Touch-N-Stop Spit & Spit Base

If your vertical broiler has the old-style spit base without the touch-n-stop slip clutch design, and you need to replace the spit or want to upgrade to the new design, please purchase the compatible assembly and follow the instructions below. If the base of your spit is square, then it is the old-style. If it is circular, then it is the touch-n-stop.

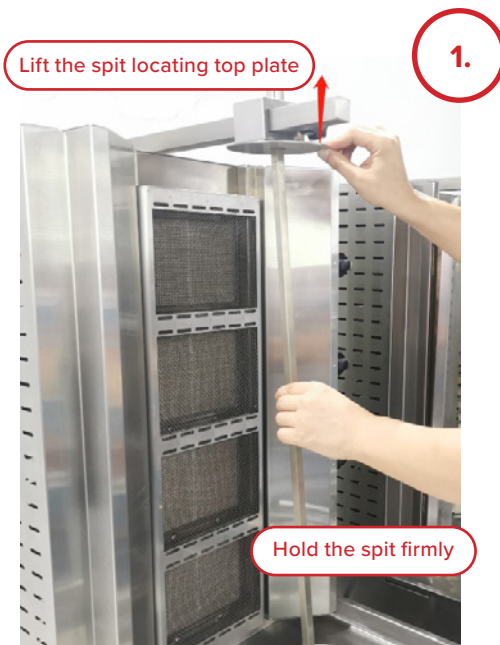
Original Spit

New Touch-N-Stop Spit

NOTE: The touch-n-stop design allows you to gently stop the spit while shaving the meat without damaging the motor.
